GE ENERGY

MFN 06-195
June 23, 2006

Subject: Responses to Methods RAIs - Interim Methods LTR

Responses to RAIs Related to NEDE-33173P

Figure R2.2-1 Sensitivity of Cold Critical Eigenvalue to EPU Operation

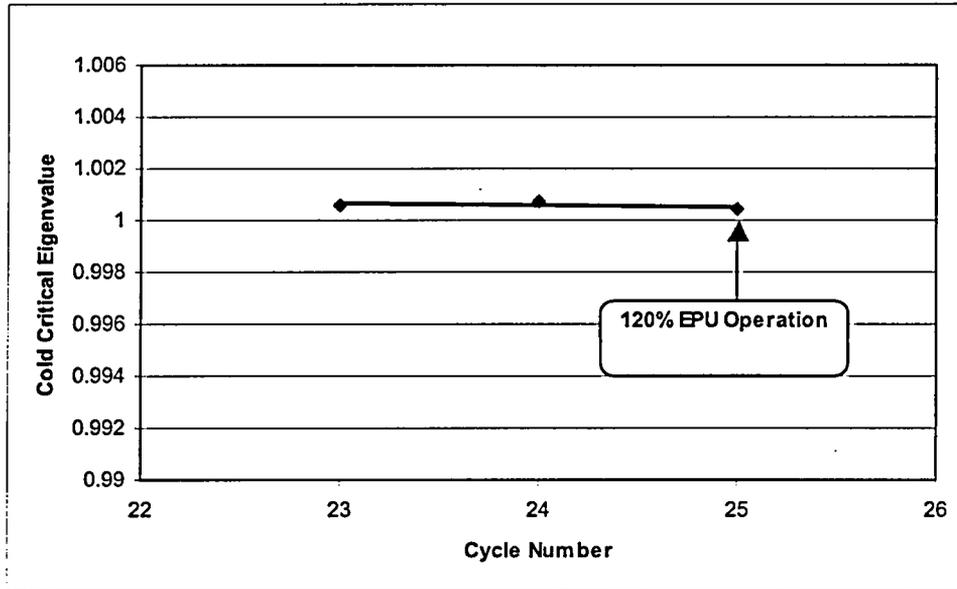
The LTR states that the same SDM Technical Specification value used for non-EPU core designs is adequate for EPU and expanded operating domain conditions. Provide the basis as to why cold SDM is not a strong function of the current operating strategies by comparing cold critical data before and after EPU. Include in the discussion the impact of core designs necessary to achieve EPU and maintain extended cycle lengths (e.g., larger batch fractions, higher bundle enrichments and different core loading patterns).

As a final demonstration of these concepts, the trending of the cold eigenvalues for a BWR/4 through a 120% EPU transition is provided in Figure R2.2-1. The scale of the data is consistent with that given in Figure 2-4 of NEDC-33173P. There is no identifiable aberration with the trend because of EPU.
